SERVICE BULLETIN

M-1029

SAFETY RECALL 081 1990 AND 1991 BIG TWIN (1340 CC) MODELS CARBURETOR FUEL INLET VALVE INSPECTION/REPAIR

Figure 2. Carburetor Disassembly

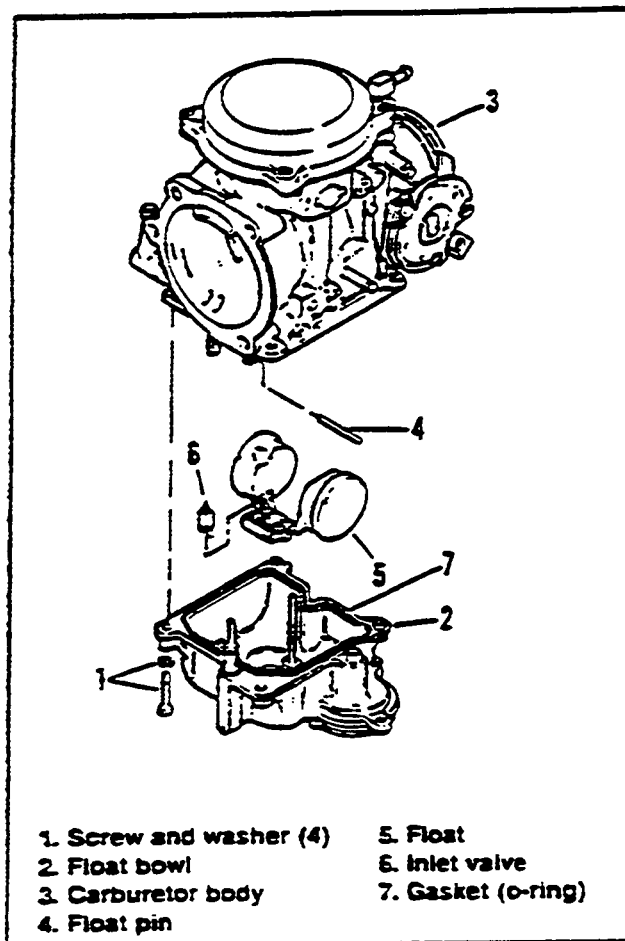
1. See Figure 2.
2. Use a needle nose VISE-GRIP® to loosen the four screws and washers (1) that secure the float bowl (2) to the carburetor body (3).
3. Remove the four screws loosened in Step 2, and remove float bowl.
4. Check float level. If inlet valve has 3-sides, see Figure 3. If inlet valve has 4-sides, see Figure 5.
5. See Figure 2. Remove float pin (4), float (5), and inlet valve (6).
6. See Figure 4. Visually inspect the inlet valve seat to verify that the small hole in the seat is concentric (centered) with the large hole. Also visually verify that the chamfer on the small hole matches the taper of the inlet valve (needle).

7. Inspect the float for cracks or leakage. If cracks or gasoline leakage into the float chambers is found the float must be replaced. See Credit Procedure in this Bulletin for instructions on obtaining a replacement float.
8. Inspect the inlet valve. If inlet valve has 3-sides, discard it. All 3-sided inlet valves will be replaced with a current production 4-sided valve. If the carburetor is already equipped with a 4-sided valve inspect the tapered point of the valve for grooves or damage on the sealing surface. If sealing surface is damaged replace the valve with a new one. If sealing surface is undamaged the valve may be reinstalled in the carburetor.

9. See Figure 2. Check float bowl o-ring (7). If o-ring is damaged it must be replaced.

Figure 5. Adjusting Float Level With 4-Sided Inlet Valve

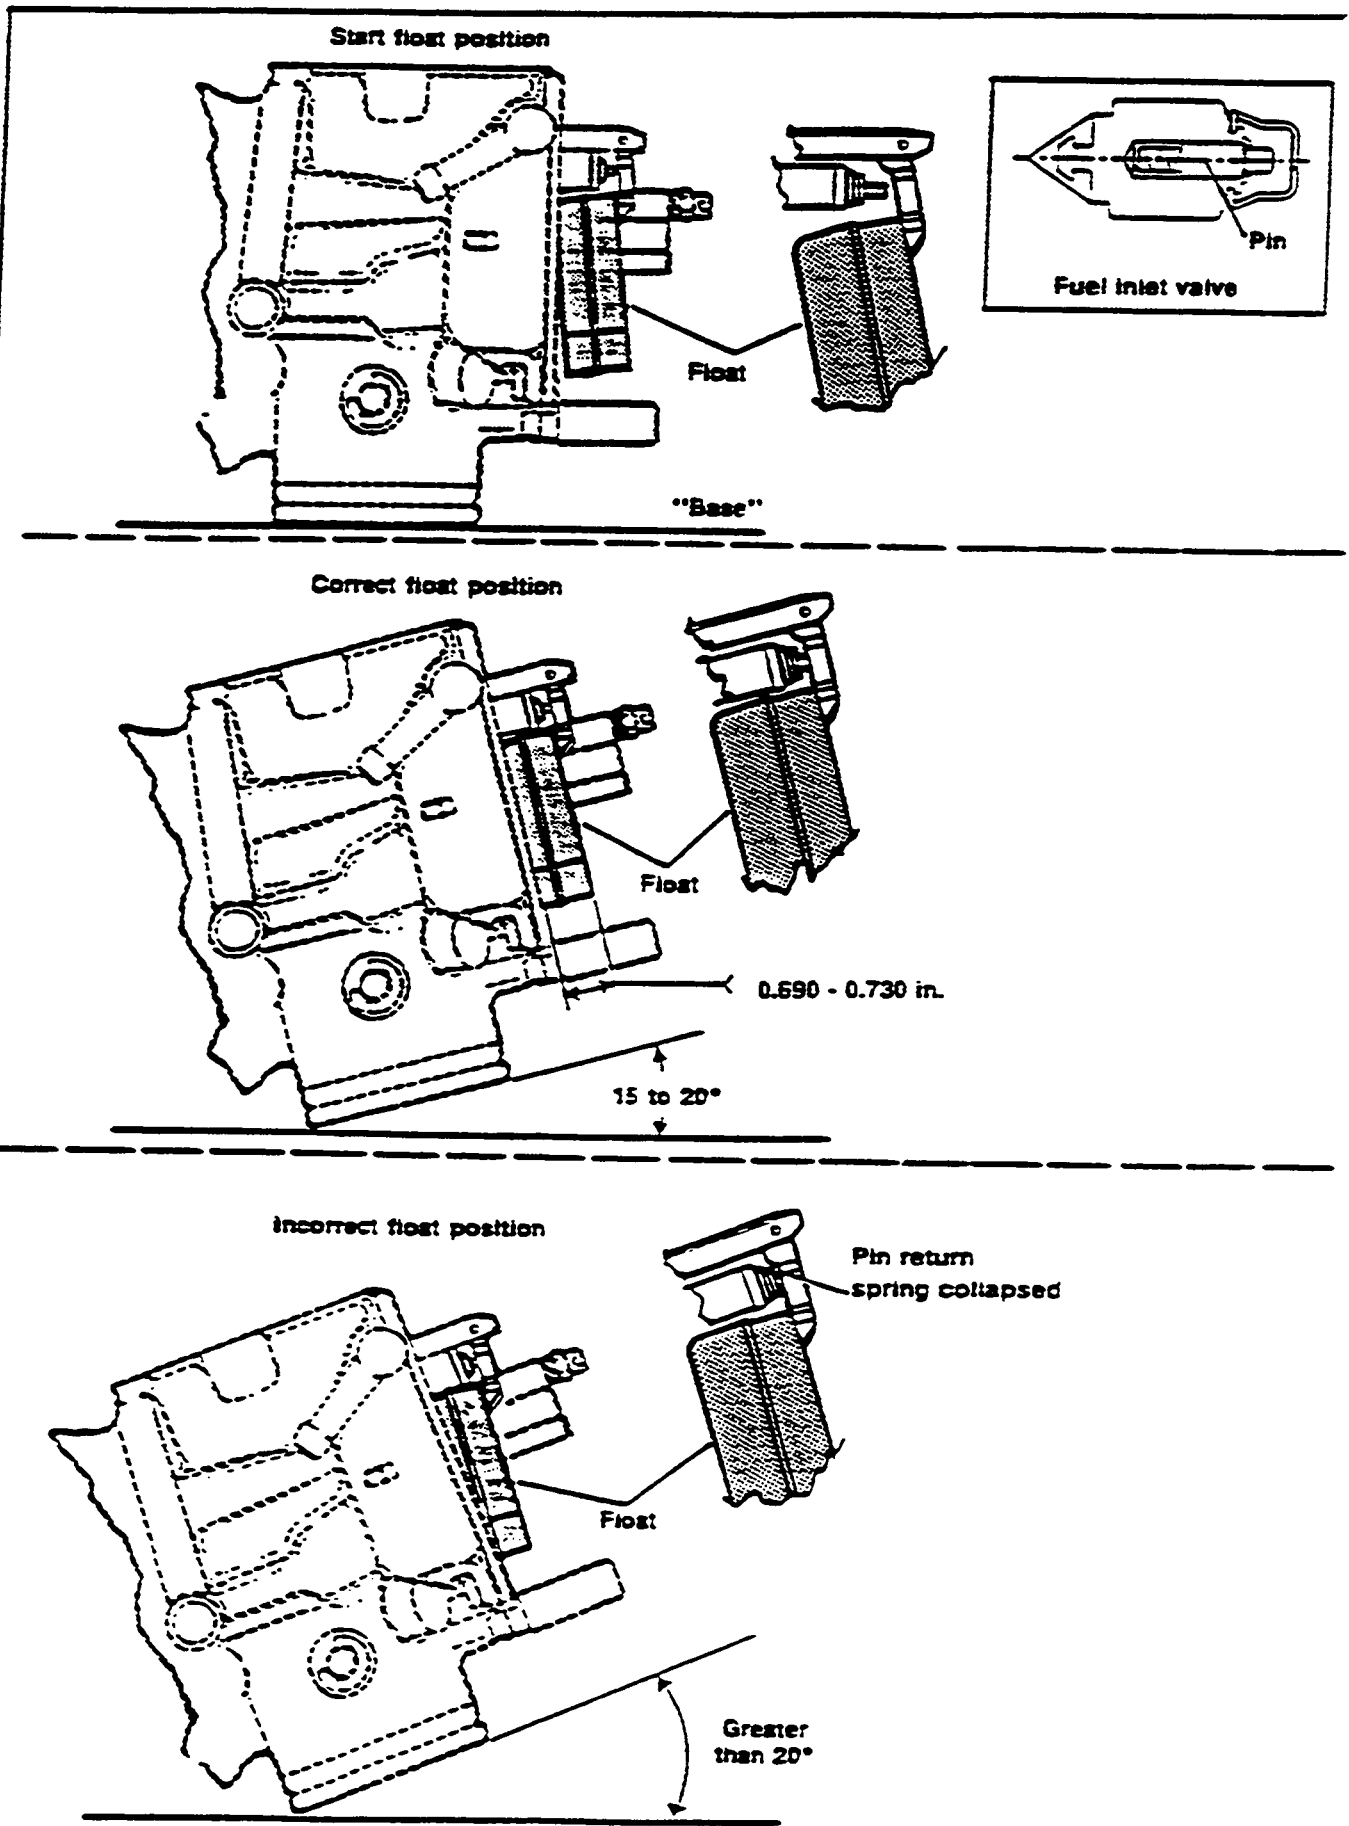
2. See Figure 5. Place carburetor on a flat, clean surface on engine manifold side. This is the "base". Tilt carburetor counterclockwise 15 to 20° from base until float comes to rest.

3. Use a vernier or dial caliper depth gauge to measure from the carburetor flange face to the perimeter of the float. Be careful not to push on float while measuring.

On 1990 and 1991 CV carburetors, the measurement should be 0.690 - 0.730 in.

5. If measurement is not within given dimension, carefully bend tab on float to position float at proper level.
